[Home](#) > [Development Assessments](#) > [Major Project Assessments](#)

Vickery Coal Project

Year 26 Simulation

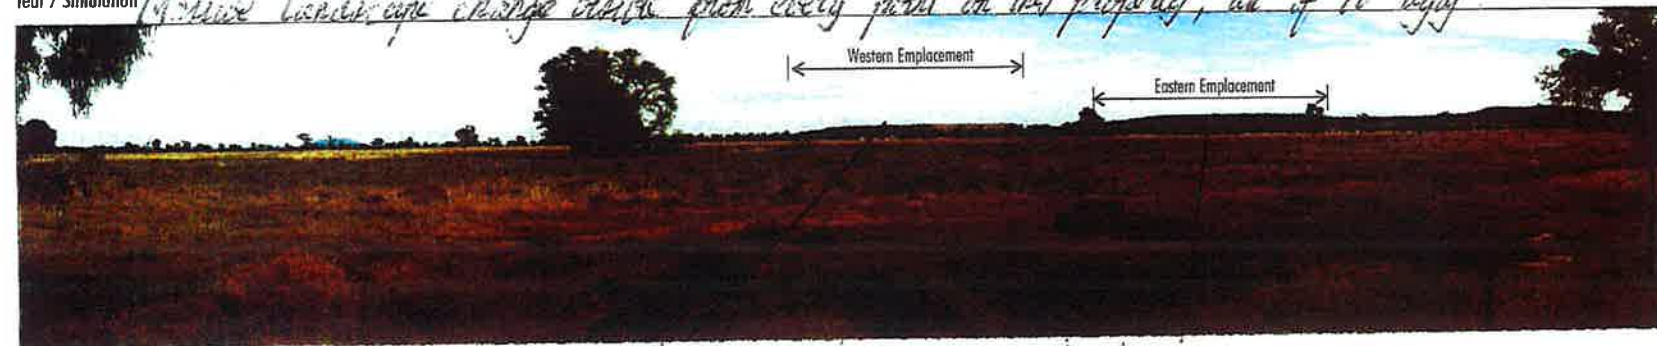
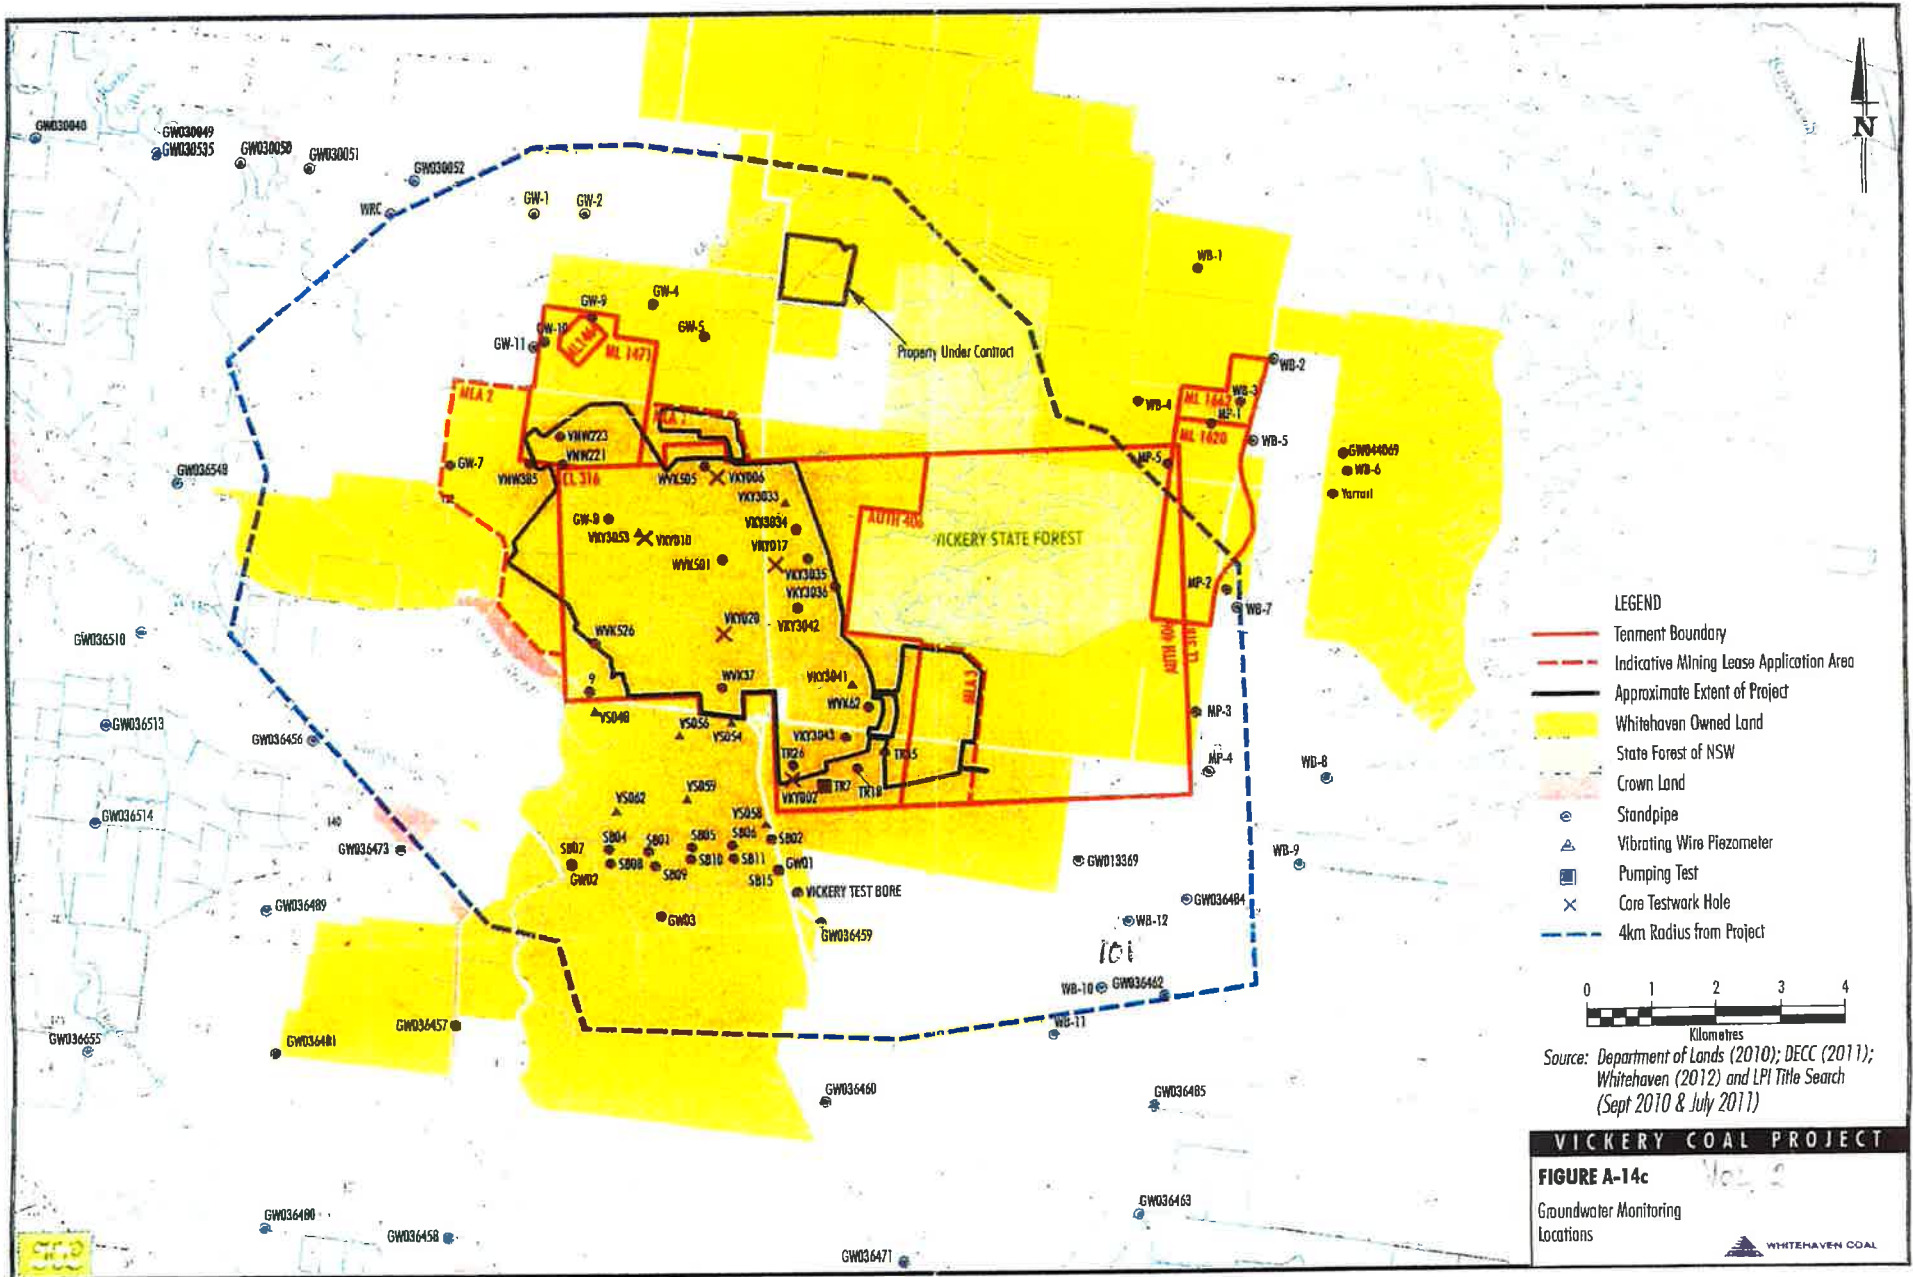
Real view is much bigger and much closer than photograph shows

Minor landscape change visible from every point on this property, all of it ugly

Both emplacements will be much bigger and far more imposing than simulation shows. Not showing 100 metres high

VICKERY COAL PROJECT
FIGURE 4-18
Project-only 24-hour Average
PM₁₀ Contours - Year 26

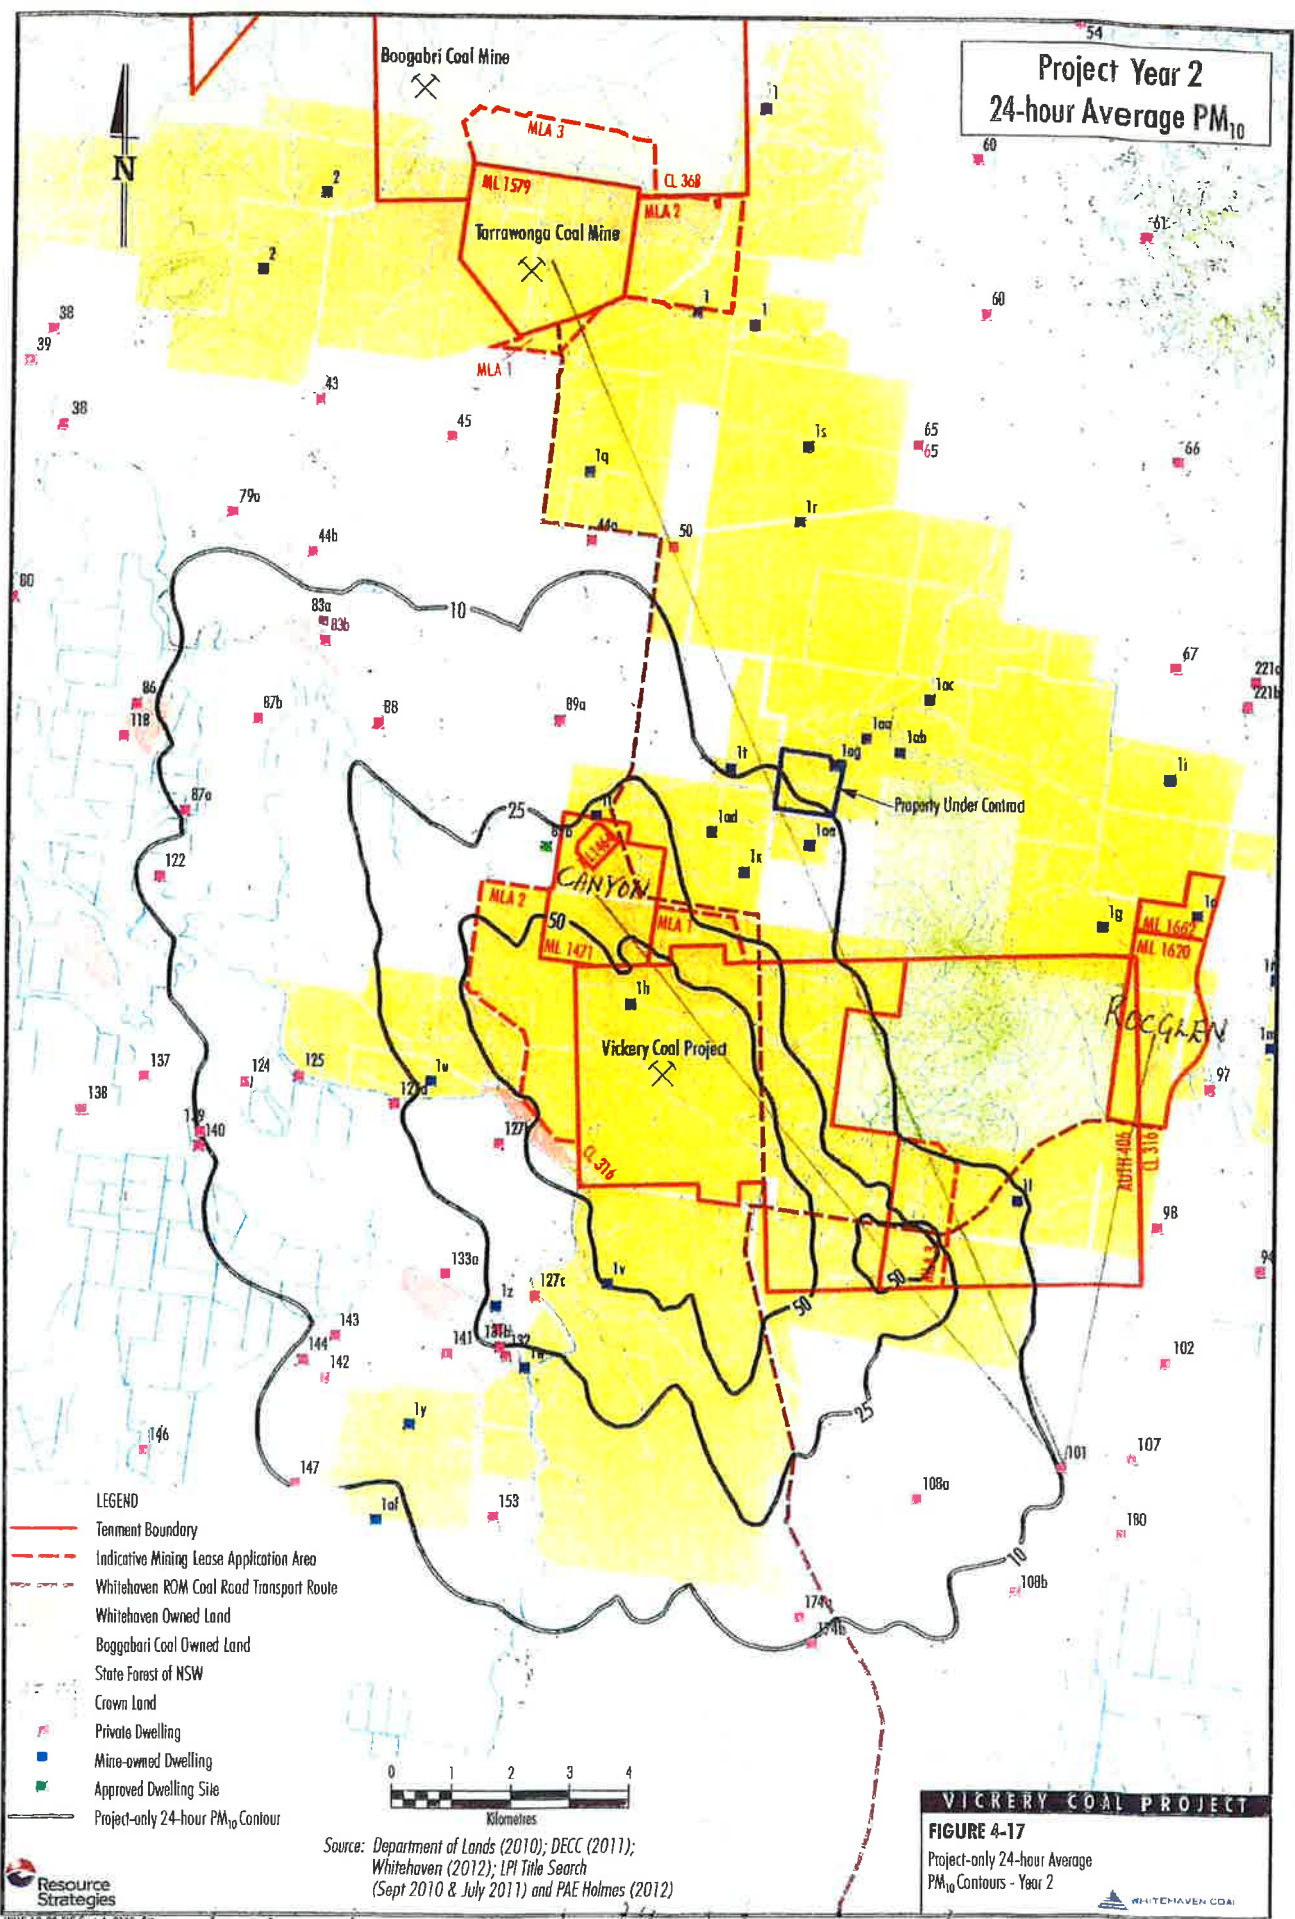
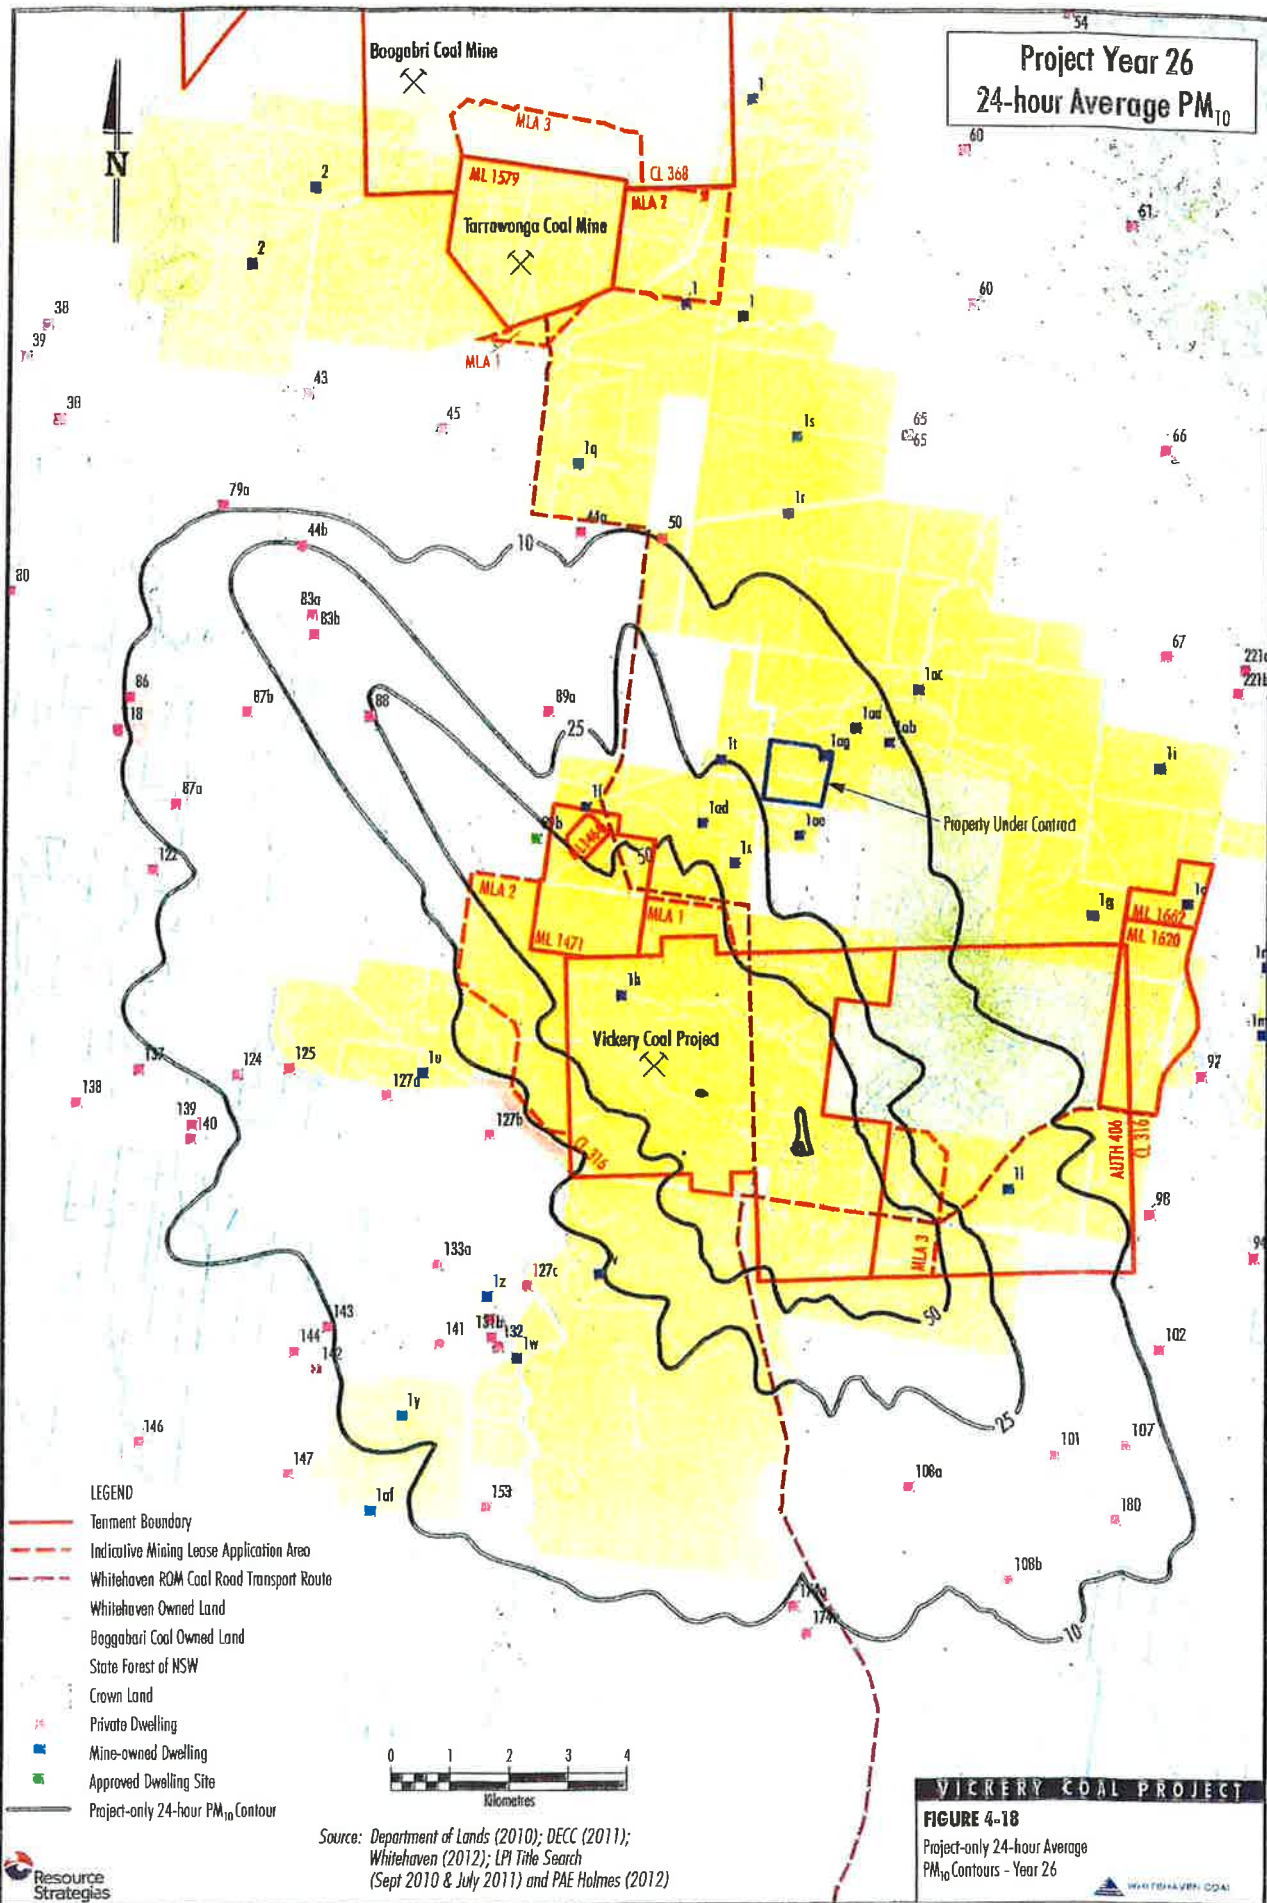
We believe noise levels will be far worse for us than computer modelling predictions show, Fig. 4-17 & 4-18. At the open day in Boggabri (September 2012) the assumption of wind carrying noise & dust from the southeast to the northwest was disputed. This direction may happen on some occasions but is not the usually prevailing as most of our weather systems come from a generally westerly to generally easterly direction with variations occurring on some occasions, mostly on a seasonal basis. We therefore believe the modelling is fundamentally incorrect and will give more noise than predicted from day 1, and will be worse as the heights of the eastern and western emplacements increase.

*Pencil lines show previously felt shaking from blasting, at 101.
Tarrawonga 24 km. Canyon 12 km. Rocglen 7 km. approx.*

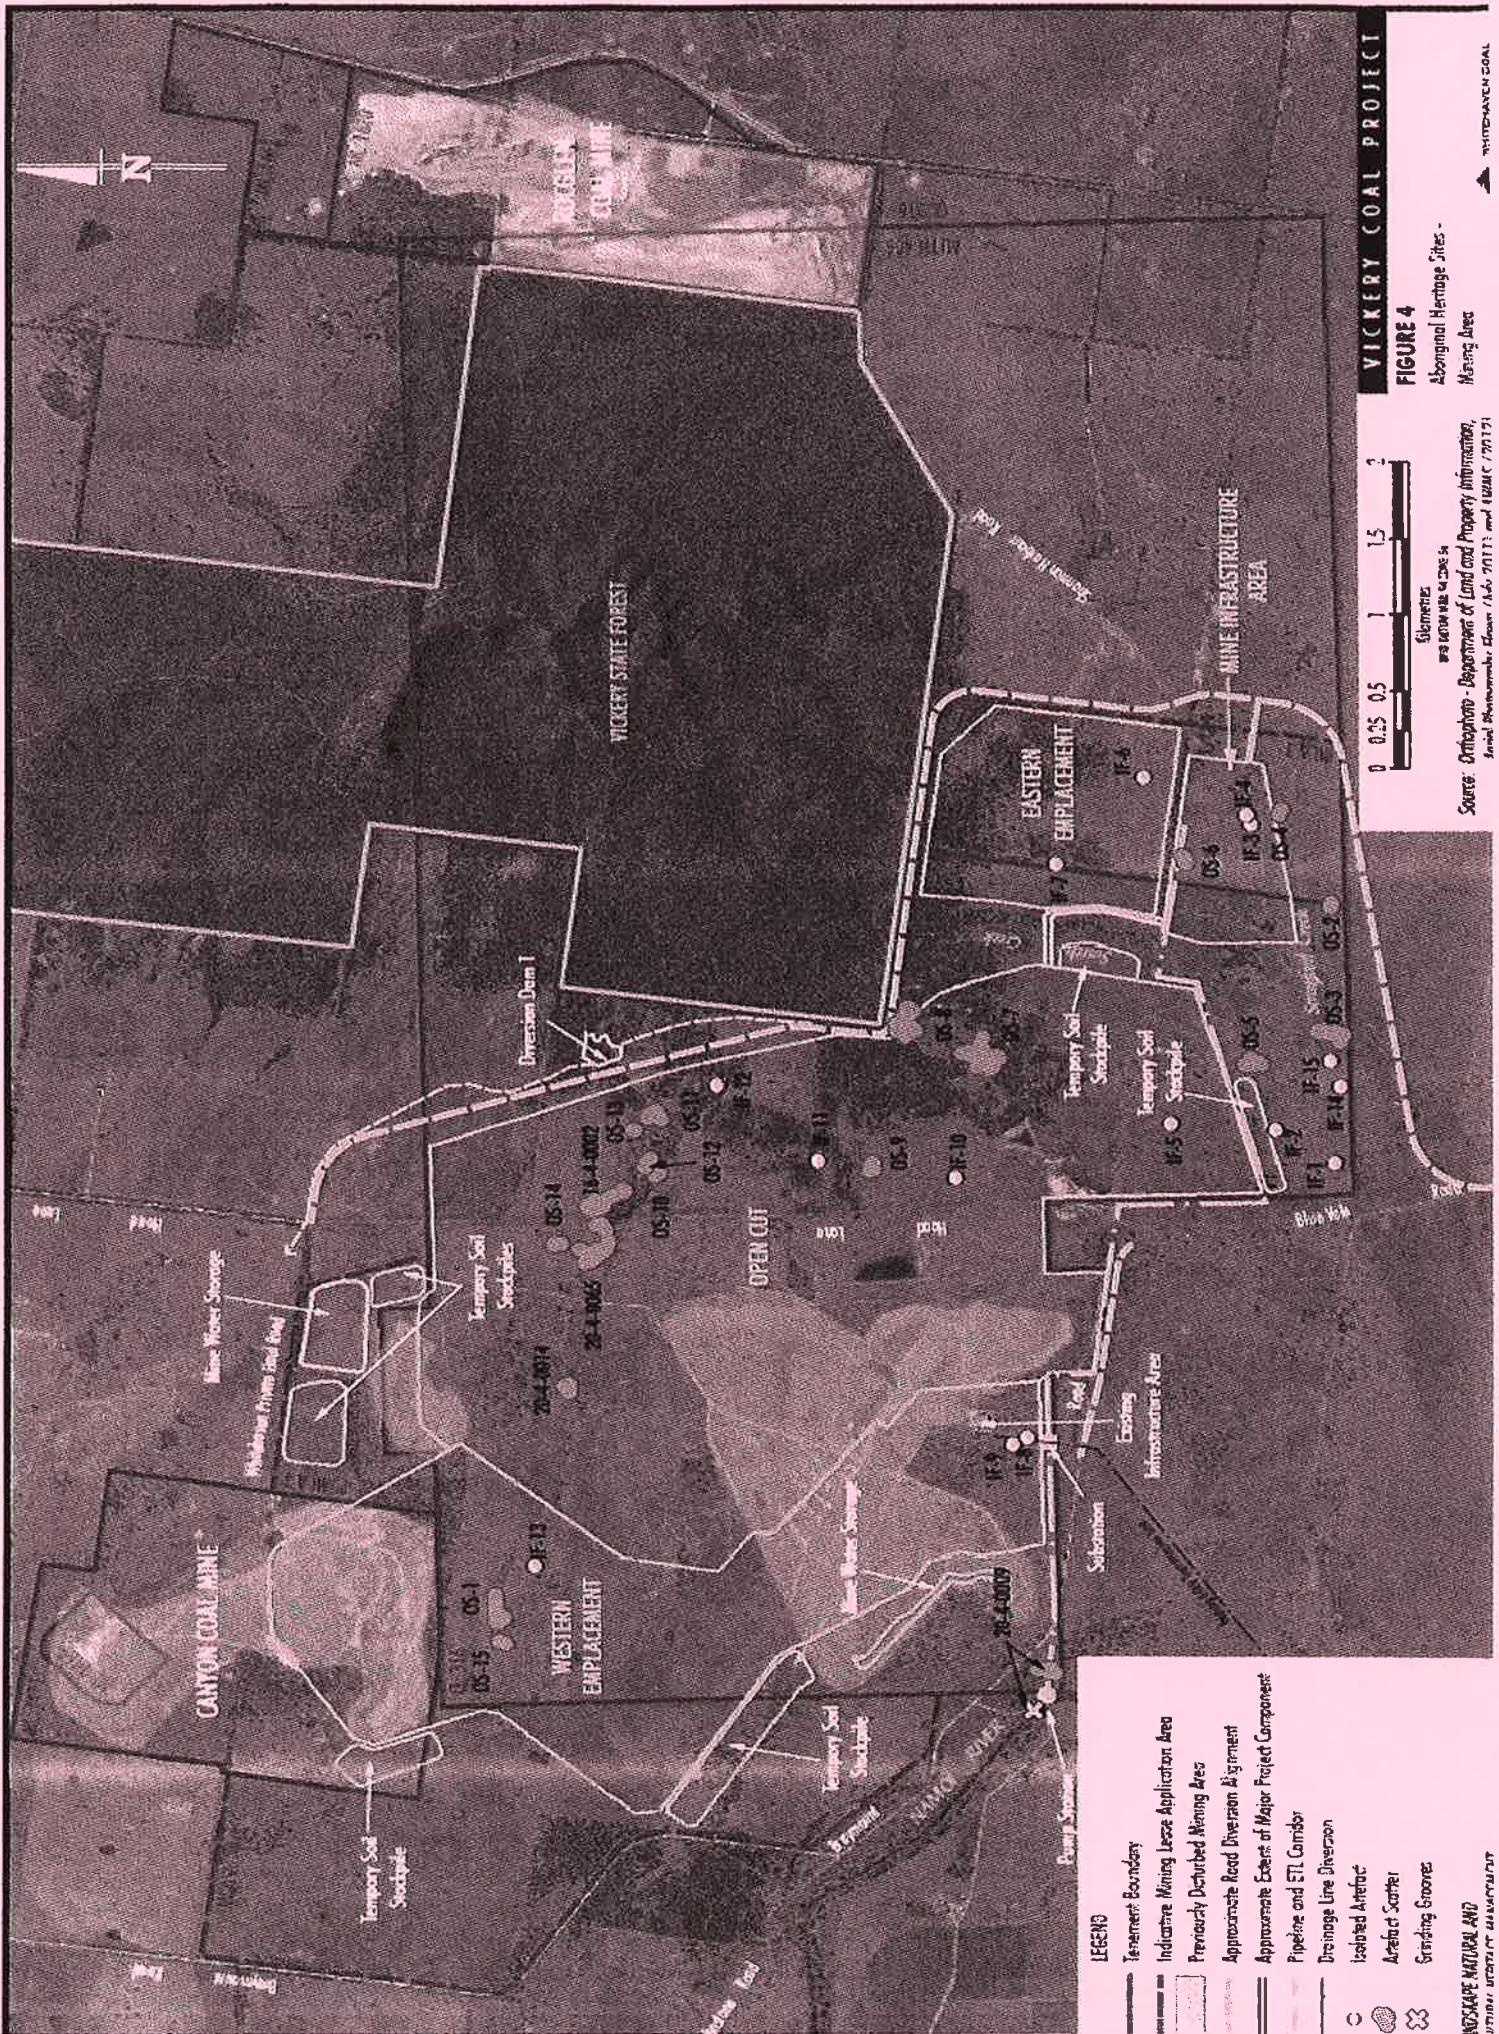
One of these sites that will not be protected as it was not adequately assessed is a rock formation found about 600m East of Hoad Lane (attached is a map of Figure 2 of the Aboriginal heritage assessment with markings). In December 2011, myself (as T'N'L Site Trackers) and fellow traditional owner Leonard Talbot were surveying part of the project area for our cultural heritage, along with Mr Lance Syme of Kayandal Archaeological Services (for Whitehaven). During the survey we discovered a rock formation described above and found that it was quite significant. However, the nature of the exact significance was not clear enough and we agreed with Mr Syme
